Determination 2010/106

Refusal of a code compliance certificate for house alterations completed under the supervision of a building certifier at 27A Parkvale Road, Karori, Wellington

2.2 The alterations considered in this determination are shown in Figure 1:

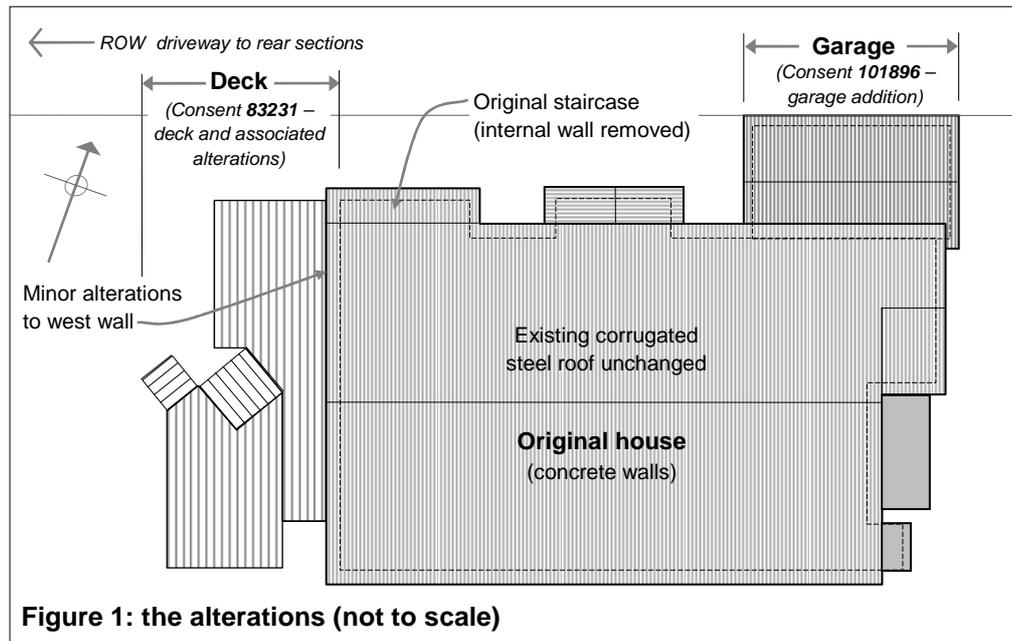
- 6.5 Commenting specifically on the external envelope, the expert noted that:
- there are fine cracks at the junction of the new plaster over the bi-fold doors to the deck and the original concrete walls, which require regular maintenance
 - the plaster above the windows butts against the head flashings, with no anti-capillary gap or allowance for drainage
 - the plaster at the timber sills butts against the solid timber sills of the rear access door to the garage
 - the plywood in the cladding of the garage butts against the concrete floor slab, and allows moisture to wick into the bottom plate
 - the timber jambs to the vehicle access door to garage the butt against the concrete.

- 7.4.2 However, the expert's report also establishes that the current performance of the garage building envelope is not adequate because it is allowing moisture penetration into the timber framing at present. Consequently, I am satisfied that the garage addition does not comply with Clause E2 of the Building Code.

- 7.4.4 Because the faults identified with the claddings occur in discrete areas, I am able to conclude that satisfactory rectification of the items outlined in paragraph 6.5 will result in the alterations being brought into compliance with Clauses B2 and E2 of the Building Code.

- 10.1 The authority should issue a notice to fix that requires the owner to bring the alterations into compliance with the Building Code, identifying the items listed in paragraph 6.5 and paragraph 8.2. The applicants should then produce a response to this in the form of a detailed proposal, produced in conjunction with a competent and suitably qualified person, as to the rectification or otherwise of the specified matters. Any outstanding items of disagreement can then be referred to the Chief Executive for a further binding determination.
